**ADVISORY BOARD ON
RADIATION AND WORKER HEALTH**

**SC&A REVIEW OF WHITE PAPER, “NIOSH RESPONSE TO
SC&A’S REVIEW OF THE SEC-00109 LANL ADDENDUM”**

**Contract No. 211-2014-58081
SCA-TR-2018-SEC005, Revision 2**

January 9, 2019

**Figure 1. Annual LANSCE Radionuclide (G/MAPs) Emissions and Offsite MEI, 1990–2002
(adapted from LANL 2003, 2018)**

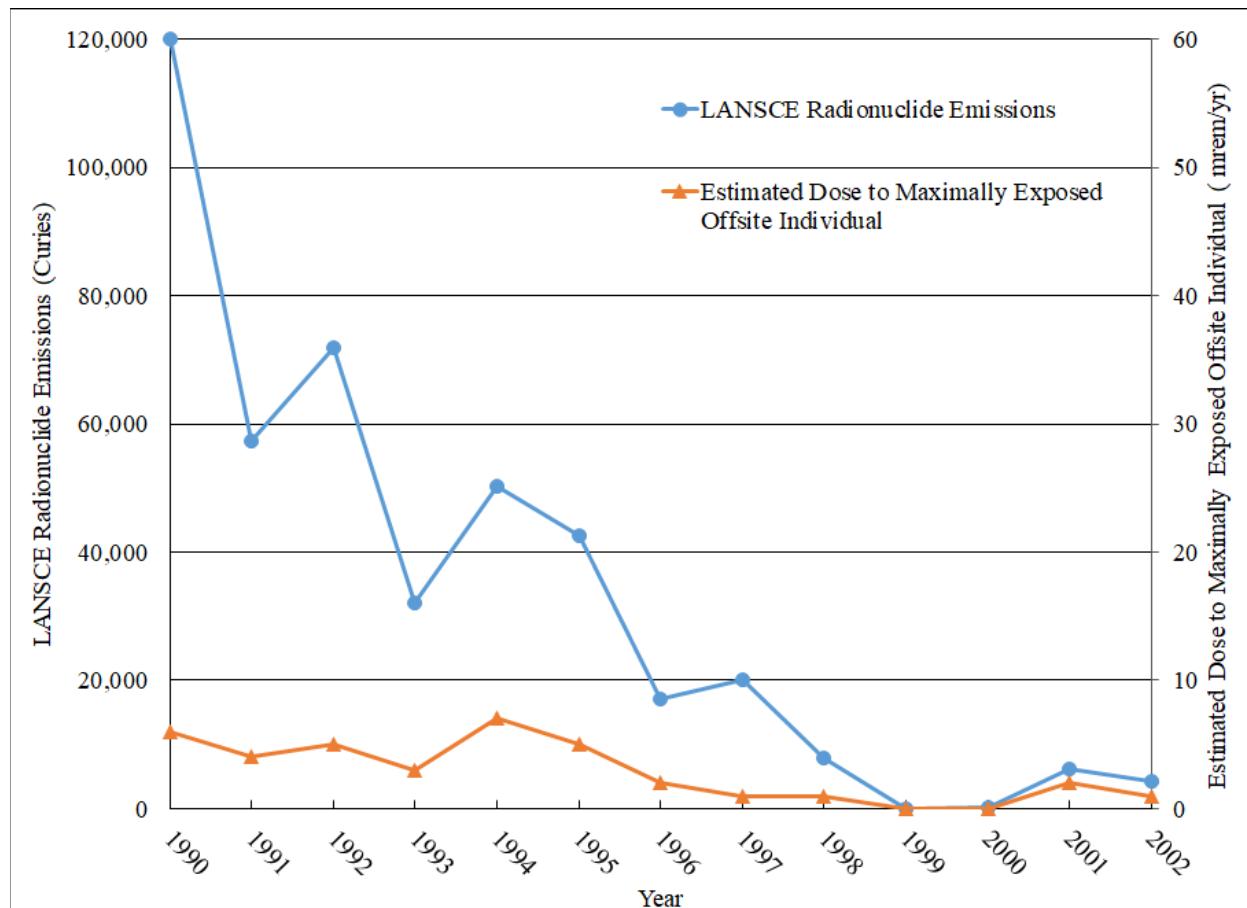
To gain some perspective in this regard, SC&A reviewed LANL environmental surveillance reports for the period 1990–2000 and found that (as noted previously) total MAPs emissions from LANSCE had declined from 120,000 Ci to almost zero by 2000, with a corresponding offsite MEI drop of 6 mrem to 0.4 mrem in that same period (LANL 2018). This is shown graphically in Figure 1.

While these constituted **average** estimated occupational doses from G/MAPs emissions for workers at LANSCE and nearby facilities, the decline of LANSCE emissions from the 1990–1995 period through to 1999 is marked and, upon further review, may warrant further attention as a starting point to characterize maximum annual occupational exposure to G/MAPs and other airborne exotics.
